Environmental Minor Project Refinement Form

Project Name: West of Devers Upgrade Project Request Prepared By: Sylvia Granados

Date Approval Required: 6/27/2018 Variance Request No.: 17

Southern California Edison
West of Devers Upgrade Project
MPR #17-
Barton Rd & California St
Distribution Change Request

FIGURE 2

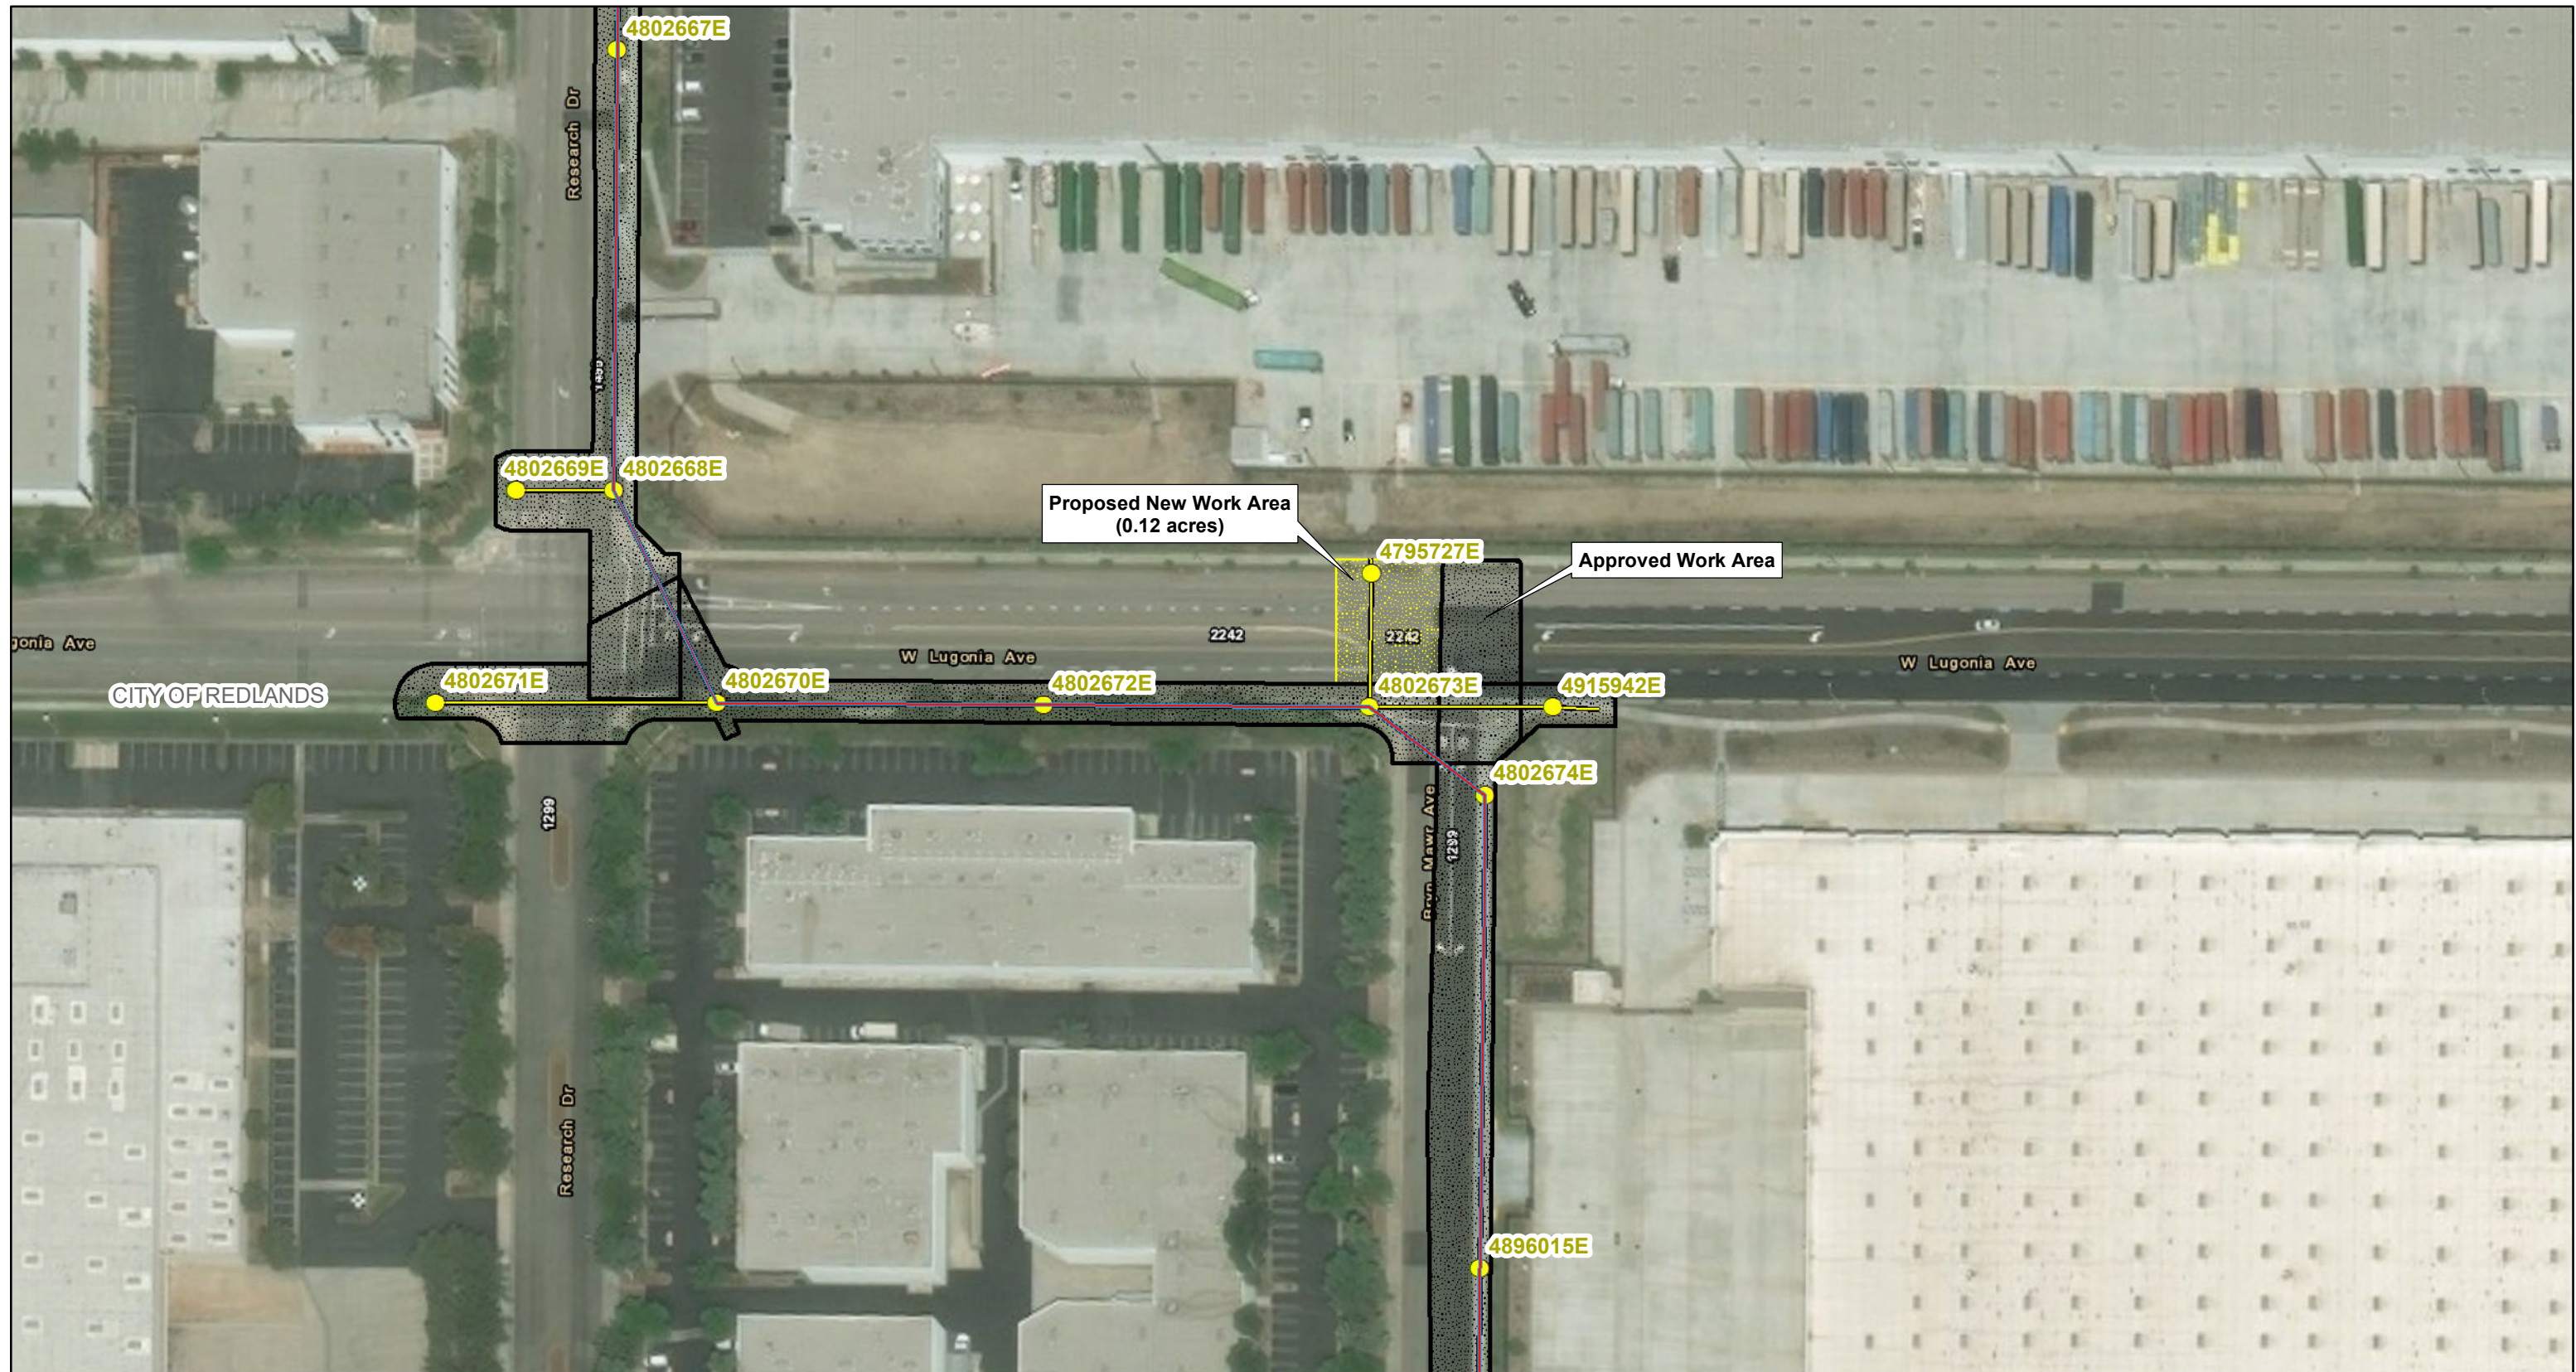
Due to the distribution duct bank adjustment along Mission Road described above, three new temporary work areas are required to facilitate the installation of structures V5652226, M5652227, and M565228, as shown in Figure 2.

The temporary impacts to developed/disturbed land associated with the redesign total 0.08 acre.
